# BRE Client Report

## Review of daylight, sunlight and overshadowing, Enterprise Point and 16-18 Melbourne Street, Brighton

Prepared for: Brighton and Hove City Council

Report Number: P114478-1000 Issue: 2

Figure 1. Plan by GIA showing the new development and the nearest surrounding buildings. North is at the top of the plan.

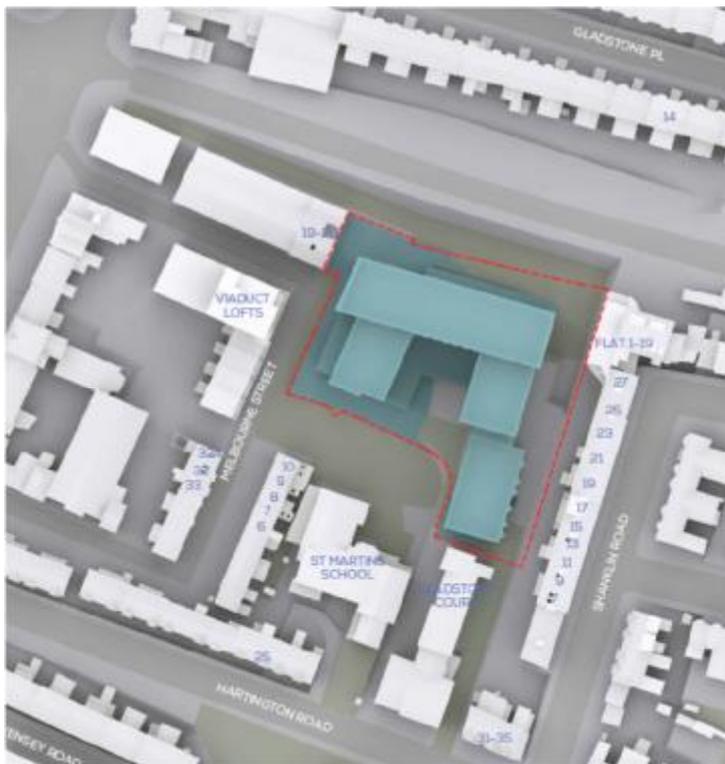
3.1.1 Figure 1, taken from GIA's report, shows the new development and surrounding areas.

- 3.1.3 The site slopes significantly from west up to east, so that the eastern boundary of the site is significantly higher, around 7-8m higher, than Melbourne Street to the west. Shanklin Road itself is even higher. GIA's model appears to have taken into account this difference in height.
